REV.  
E

AS3240™

BOLT, MACHINE - DOUBLE HEXAGON EXTENDED  
WASHER HEAD, PD SHANK, NICKEL ALLOY,  
UNS N07718, 185 KSI MIN, .4375-20 UNJF-3A

ISSUED 1980-07 REAFFIRMED 2007-06 REVISED 2022-08

FIGURE 1 - BOLT

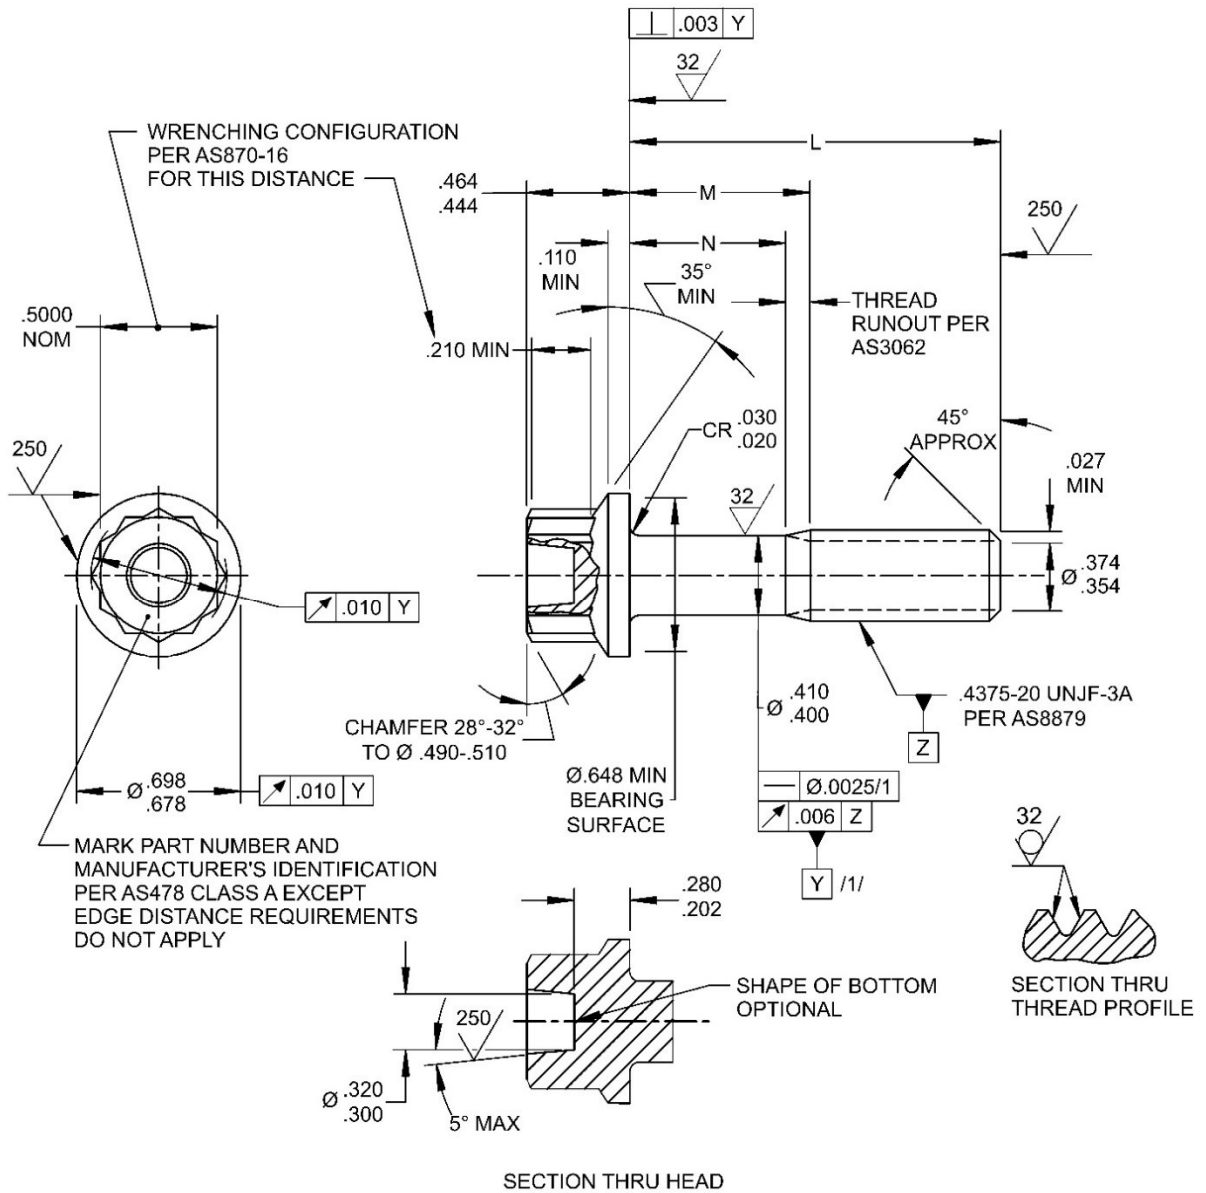
UPDATE TO ASME Y14.5-2018. REVISE LEAD THREAD CHAMFER TO AS1132. REVISE LIGHTENING HOLE CONFIGURATION TO AS1132. REVISE FILLET RADIUS TO CR. ADD "COMPOSITION SIMILAR TO" TO NOTE 2.
